Access Compliance Report Public Rights-of-Way (RR Crossings)

Intersection ID: 12504	Main Street: N_BREVARD_ST	Location: N/A
ADA ID: 242C057F8A04	Overall Compliance: No	Severity Score: 0.0
Codes/Mitigation Info/Possible Solution		Field Measurements/Component Compliance

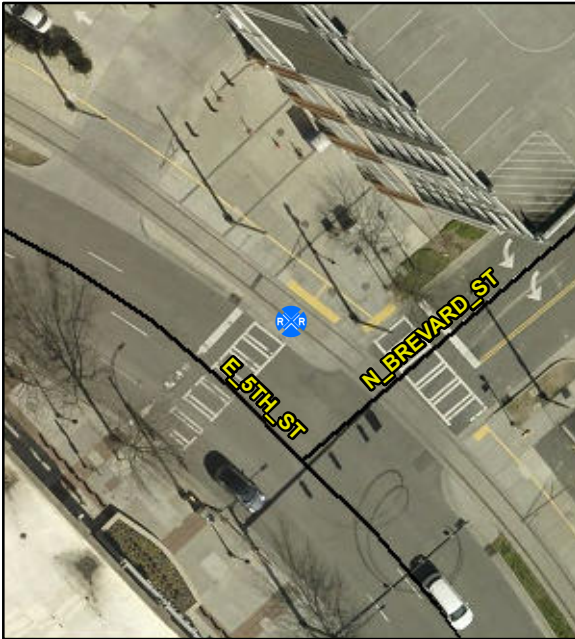
Compliance	Description	Data
Yes	DWS Provided?	Yes
Yes	DWS Contrast?	Yes
Yes	DWS Width (in)	Yes
Yes	DWS Length (in)	24.0
No	DWS Offset (in)	16.5
No	Pedestrian Gate?	No
N/A	DWS Outside Gate?	No
N/A	Rail Type?	LightRail
No	Flangeway Gap (in)	2.5
Yes	Sidewalk Width (in)	160

**Remove & Replace Detectable
Warning System. Provide Pedestrian
Gate. Remove & Replace Walking
Surface Adjacent to Rail.**
